Access Compliance Report

Public Rights-of-Way

Intersection ID: 24524	Main Street: CELBRIDGE_CT	Cross Street: SAINTFIELD_PL	Location: SE
ADA ID: ACEED07E3FDD	Ramp Type: PerpDiag	Initial Pass/Fail: Fail	Overall Compliance: No
Severity Score: 12.5			
Codes/Mitigation Info/Possible Solution		Field Measurements/Component Compliance

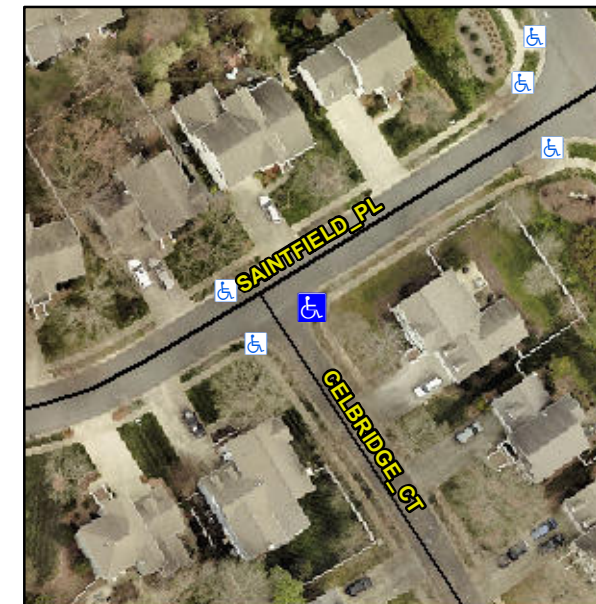
Not Found, R304.2.2

Compliance	Description	Data	Compliance	Description	Data
N/A	Ramp Length (in)	48.0	No	Ramp Slope (%)	10.6
Yes	Ramp Width (in)	48.0	Yes	Ramp XSlope (%)	1.4
N/A	Flare Type LT	N/A	N/A	Flare Type RT	N/A
N/A	Flare Slope LT (%)	N/A	N/A	Flare Slope RT (%)	N/A
N/A	Flare Traversable LT?	N/A	N/A	Flare Traversable RT?	N/A
N/A	Landing Length (in)	N/A	N/A	DWS Provided?	N/A
N/A	Landing Width (in)	N/A	N/A	DWS Contrast?	N/A
N/A	Landing Slope (%)	N/A	N/A	DWS Length (in)	N/A
N/A	Landing X Slope (%)	N/A	N/A	DWS Full Width?	N/A
N/A	Landing Curb? (Y/N)	N/A	N/A	DWS Offset (in)	N/A
N/A	Shared Landing?	N/A			
N/A	Gutter Ponding?	Yes	N/A	Gutter Slope (%)	N/A
N/A	Gutter Lip Ht (in)	N/A	N/A	Gutter X Slope (%)	N/A
N/A	Painted X Walk1?	No	N/A	Painted X Walk2?	No
	X Walk 1 Direction	To N		X Walk 2 Direction	To W
N/A	X Walk 1 Width (in)	N/A	N/A	X Walk 2 Width (in)	N/A
	X Walk 1 Slope (%)	6.0		X Walk 2 Slope (%)	0.7
	X Walk 1 X Slope (%)	1.2		X Walk 2 X Slope (%)	2.7

Remove & Replace Curb Ramp With Two New Directional Ramps or Equivalent.
